## **GLOBAL REGISTRY**

### Addendum

#### **Global technical regulation No. YYY**

TECHNICAL REQUIREMENTS for *QUIET ROAD TRANSPORT VEHICLES with regard to  
the sound emissions.*

Diagram C:

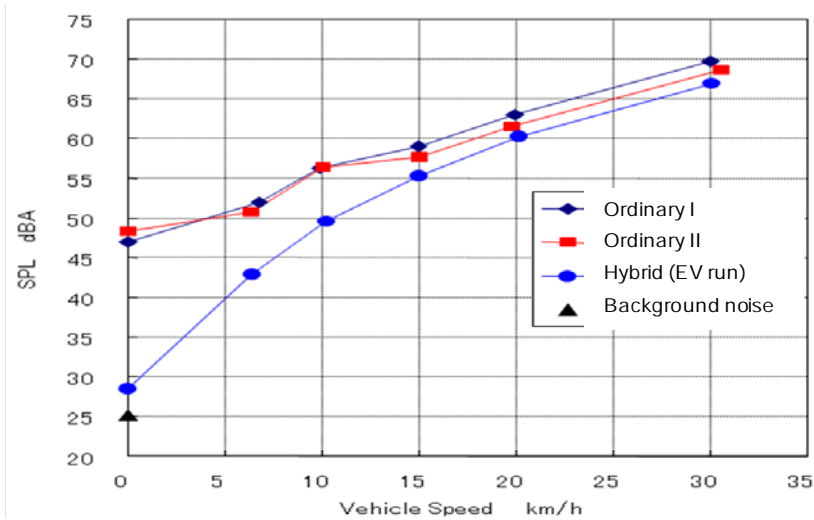
*Japan may wish to update this chart*
